# Access Compliance Report

## Public Rights-of-Way

Intersection ID: N/A	Main Street: PROVIDENCE_RD	Cross Street: SOUTHGROVE_ST	Location: SE
ADA ID: 79269CB54EFD	Ramp Type: PerpDiag	Initial Pass/Fail: Fail	Overall Compliance: No
Severity Score: 12.5			
Codes/Mitigation Info/Possible Solution		Field Measurements/Component Compliance

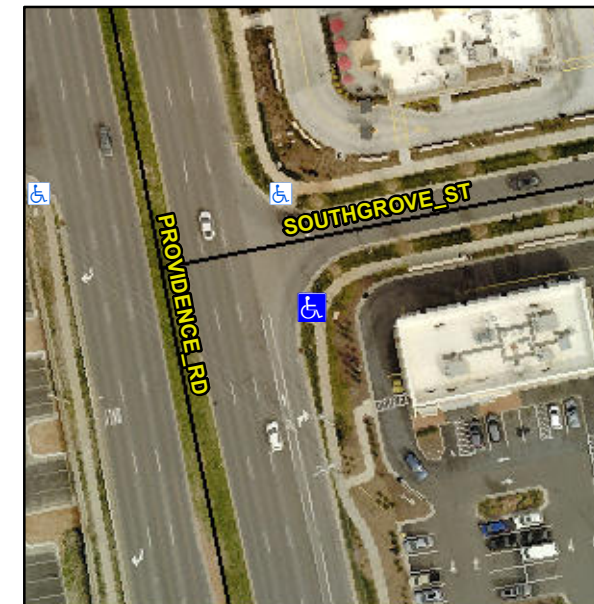
**Not Found, R304.5.3**

Compliance	Description	Data	Compliance	Description	Data
N/A	Ramp Length (in)	96.0	Yes	Ramp Slope (%)	6.5
Yes	Ramp Width (in)	48.0	No	Ramp XSlope (%)	5.6
N/A	Flare Type LT	N/A	N/A	Flare Type RT	N/A
N/A	Flare Slope LT (%)	N/A	N/A	Flare Slope RT (%)	N/A
N/A	Flare Traversable LT?	N/A	N/A	Flare Traversable RT?	N/A
N/A	Landing Length (in)	N/A	N/A	DWS Provided?	N/A
N/A	Landing Width (in)	N/A	N/A	DWS Contrast?	N/A
N/A	Landing Slope (%)	N/A	N/A	DWS Length (in)	N/A
N/A	Landing X Slope (%)	N/A	N/A	DWS Full Width?	N/A
N/A	Landing Curb? (Y/N)	N/A	N/A	DWS Offset (in)	N/A
N/A	Shared Landing?	N/A			
N/A	Gutter Ponding?	N/A	N/A	Gutter Slope (%)	N/A
N/A	Gutter Lip Ht (in)	N/A	N/A	Gutter X Slope (%)	N/A
N/A	Painted X Walk1?	No	N/A	Painted X Walk2?	No
	X Walk 1 Direction	To N		X Walk 2 Direction	To W
N/A	X Walk 1 Width (in)	N/A	N/A	X Walk 2 Width (in)	N/A
	X Walk 1 Slope (%)	1.4		X Walk 2 Slope (%)	5.3
	X Walk 1 X Slope (%)	4.2		X Walk 2 X Slope (%)	4.2

**Remove & Replace Curb Ramp With Two New Directional Ramps or Equivalent.**
